**MARYLAND DEPARTMENT OF THE ENVIRONMENT  
AIR AND RADIATION ADMINISTRATION**

**FINAL DETERMINATION CONCERNING A  
PERMIT-TO-CONSTRUCT, PSD APPROVAL, AND NSR APPROVAL APPLICATION  
SUBMITTED BY US WIND, INC. FOR THE CONSTRUCTION AND COMMISSIONING  
OF THE MARYLAND WIND OFFSHORE PROJECT**

**MARYLAND DEPARTMENT OF THE ENVIRONMENT  
AIR AND RADIATION ADMINISTRATION  
RESPONSE TO COMMENTS  
FOR THE  
US WIND INC. - MARYLAND OFFSHORE WIND PROJECT  
APPROXIMATELY 10 NAUTICAL MILES OFF THE COAST OF  
WORCESTER COUNTY, MARYLAND**

### Observed Wind Data – Ocean City Airport

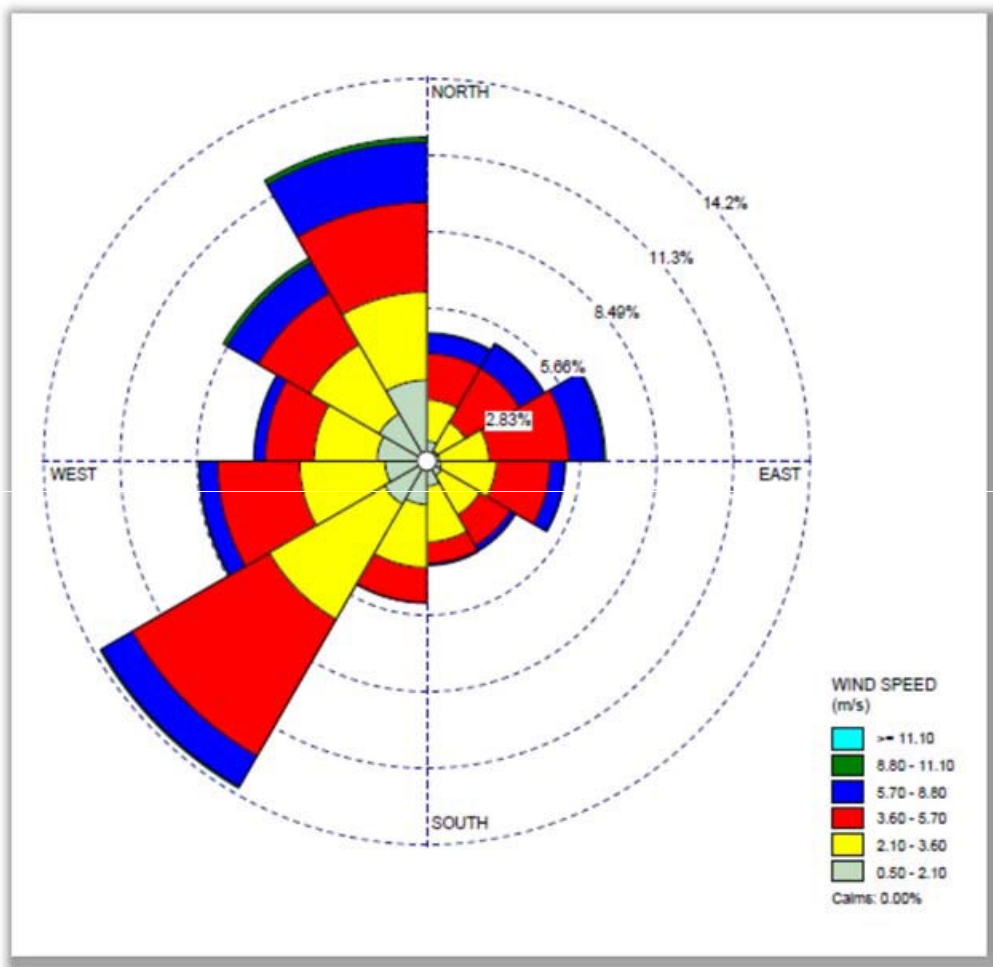
Comments related to the potential significant impact of the wake effect from the offshore wind turbines. A commenter asked, "if a permit can be denied only based on the potential impact of this effect." There have been some concerns on how the potential wake effect may also impact or increase ozone levels.

Another commenter shared concerns related to the potential impact that wind turbines could have due to the potential increase in the ozone layer in nearby urban areas.

Wake effect" refers to the phenomenon downstream from a wind energy facility, which results from the changes in wind speed caused by the impact of turbines on each other. When wind passes through a turbine, the blades extract energy from the wind, which reduces the wind speed and changes its direction in the area immediately downstream of the turbine, creating a "wake" region characterized by reduced wind speed and turbulence.

Wind turbine wake effects would have minimal to no impact on the ozone (O<sub>3</sub>) levels along Maryland's coastline, or near more local areas (i.e., Ocean City) and inland areas in nearby counties on the Eastern shore. The wind farm (turbines) will be operating at a distance of approximately 10.0 nautical miles (~18.5 km, 11.5 miles) offshore from the nearest shoreline.

Near Ocean City, the wind generally blows from the northwest toward the southeast or from the southwest toward the northeast. This is documented in the wind rose created using wind speed and direction collected at Ocean City Airport (taken from Appendix B – Meteorological Data Evaluation, US Wind – Maryland Offshore Wind Project Air Quality Modeling Protocol).

Since the wind near Ocean City is generally moving off-shore, and because the wake effect is felt in the same direction as the wind is blowing but after (i.e. behind) the wind turbine, the wake of the wind turbine generators would generally be moving toward the open ocean. Figure 1-2 in the permit application shows the location of the wind farm in relation to the coastline. Based on the prevailing wind, the wakes of the wind turbine generators will predominantly be on the east, or the northeast side of the wind farm on the open ocean side, not toward the coastline.
